RRP Service Bulletin No: 203

Subj: ANCHOR REMOVER WORKHEAD LIFTING PLATES

Ref: (a) Anchor Remover Parts and Operating Manual (RRP P/N: 910507-M)

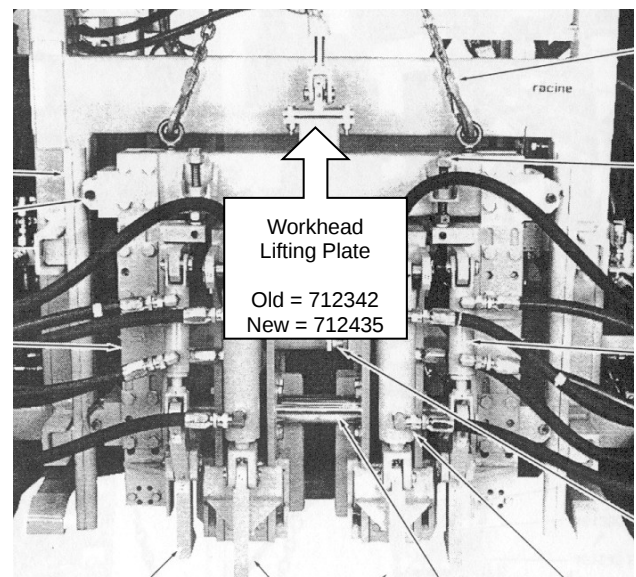
One of these changes was to increase the material thickness of the lifting plate. The old lifting plate (RRP P/N: 712342) used 1/2" thick material and the current one (RRP P/N: 712435) uses 1" material to accommodate increased weight.

The new part number change is not reflected in all printings of the service manual, so old lifting plates have been installed on workheads in the field. Overtime, the old 1/2" thick lifting plates bend and/or crack in service and should be replaced with 1" thick lifting plates. Keep the shim washers between the lifting plate and workhead, and reuse the nuts, bolts and washers.

1. Turn the battery Master Switch "ON," start the engine, close the Hydraulic Bypass Valve and lower the Workhead until it is either suspended in the Safety Chains or rests on the rail.
2. Remove a Cotter Pin and the 1" Pin to disconnect the Lifting Plate from the Head Lift Cylinder.
3. Remove the Lifting Plate 712342 (1/2" thick) and replace it with Lifting Plate 712435 (1" thick).

Note: Keep the Shim Spacers (Item 27, P/N: 389675) between the Lifting Plate and Workhead, and reuse the 1/2-13 x 2.5" bolts, washers and locknuts.

1. Page 53; 713016 Workhead, Outside View
 - a. Change item 24 from 712342 to 712435
